WESTLAND DISTRICT COUNCIL

SECTION 42A REPORT ADDENDUM

FILE REFERENCE: RC220120 & 230030

SUBJECT Report on a Limited Notified Consent Application – Addendum due to application amendments received 03 October 2023 and 06 November 2023.

Figure 1: Amended Subdivision Scheme Plan – Surveying & Development Consulting Limited – 25 August 2023.

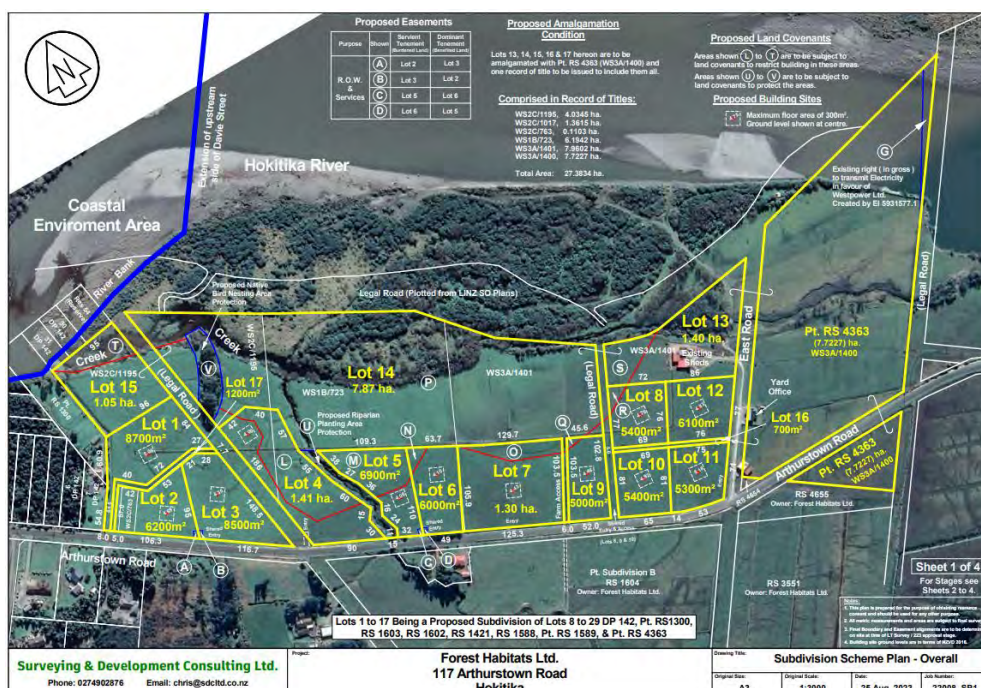
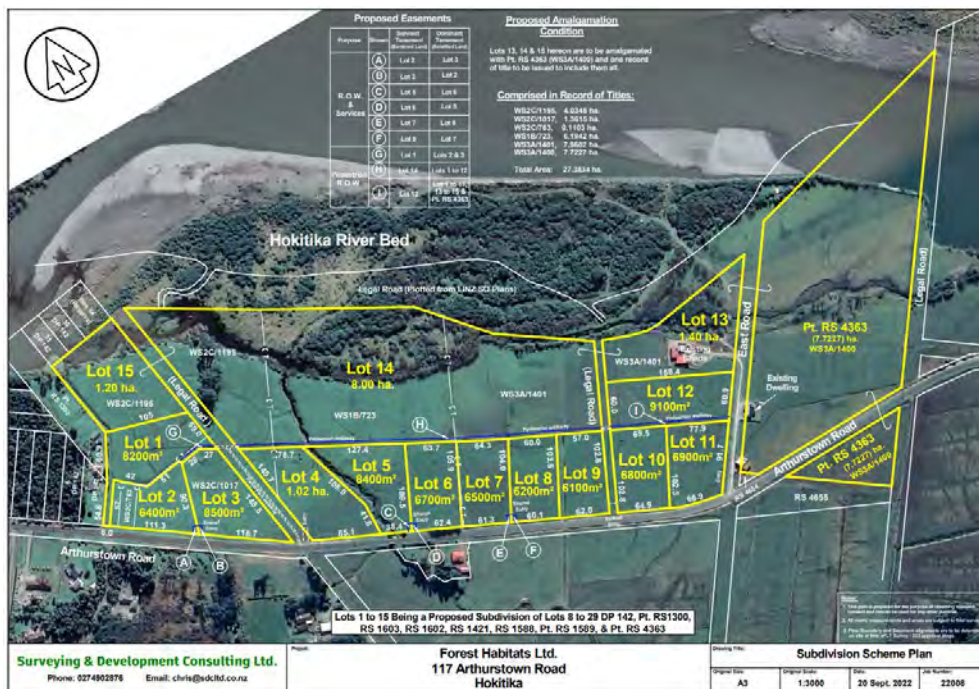
- 2.3 The proposed layout has been amended to address character and amenity concerns, such as producing an urbanised ribbon development within a Rural Zone (Operative Westland District Plan ODP) and General Rural Zone (Proposed Te Tai o Poutini Plan PDP). The amended lot boundaries will also produce more appropriate allotments in respect to topographical and natural hazard restrictions as advised through revised engineering advice. The subdivision will continue to be undertaken in three stages.
